HND and HNDFUE Impact Assessments

Ossian and North Cluster 2 Outcome Summary

April 2025

Map showing the design change – locations are illustrative and not to scale. Final design configuration is subject to further detailed network design.

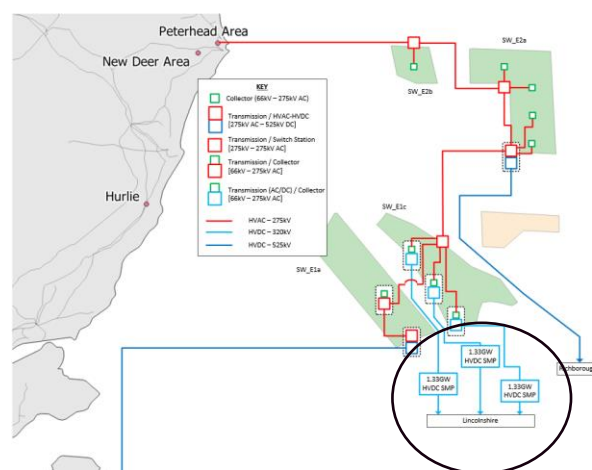
On 22 April 2024, we received a proposed design change from the Ossian offshore wind farm, one of four wind farms which are electrically connected offshore as part of the Holistic Network Design Follow Up Exercise (HND FUE) recommended design. Ossian is being developed by a partnership with SSE Renewables (SSER), Marubeni Corporation (Marubeni) and Copenhagen Infrastructure Partners (CIP).

The proposed change is primarily a change in technology of the export links (subsea cables) from the Ossian offshore wind farm to Lincolnshire. To support this an additional subsea export circuit is required together with an offshore platform and onshore substation with associated electrical equipment.

The proposed design change option performed better against the four design objectives, to the updated version of the HND FUE baseline design (the counterfactual). The original baseline is no longer deemed a direct comparator considering the identified risk with the existing technology. This means there is no reason not to proceed with the option proposed, and the Ossian project can continue to develop the project's detailed network design based on three 1.33 GW symmetrical monopole links from the Ossian offshore wind farm to substations in Lincolnshire, as shown on the map.

(Map showing the design change – locations are illustrative and not to scale). Final design configuration is subject to further detailed network design.

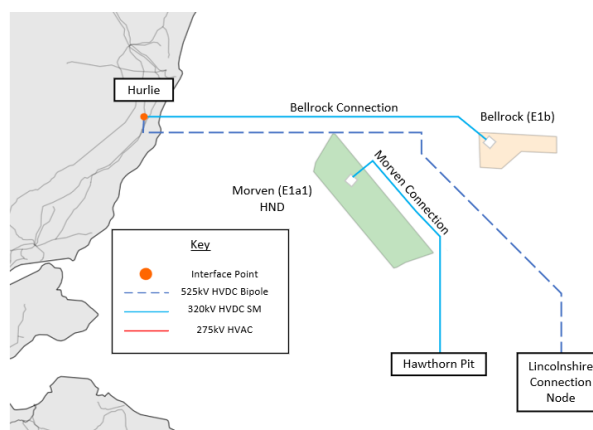
In May 2024, we received a proposed design change from the HND North Cluster, the parties which were due to be electrically connected off the east coast of Scotland and include the Transmission Owners (TOs) Scottish and Southern Electricity Networks Transmission (SSEN-T) and National Grid Electricity Transmission (NGET) and the offshore wind farms being developed by partnerships: Morven Offshore Wind Farm (BP and EnBW) and Bellrock Offshore Wind Farm (BlueFloat Energy and Nadara).

The proposed change was centred around multiple variations of network topology (coordinated and radial options) for the coordinated offshore hub, prepared by the cluster and submitted to us for assessment. Extensive supply chain engagement on feasibility of topology options was conducted in parallel and shared to support the impact assessment process.

The conclusion of our analysis resulted in Bellrock connecting directly into Hurlie and Morven connecting directly into Hawthorn Pit, emerging as the preferred option. Coordinated designs, particularly when simplified into a more modular solution do offer balance across the four design objectives. However, due to the limited market uptake of bespoke solutions and technology maturity level, continuing with the recommended design could cause delay to the delivery of critical onshore reinforcements and a potential risk of delay to clean power connections.
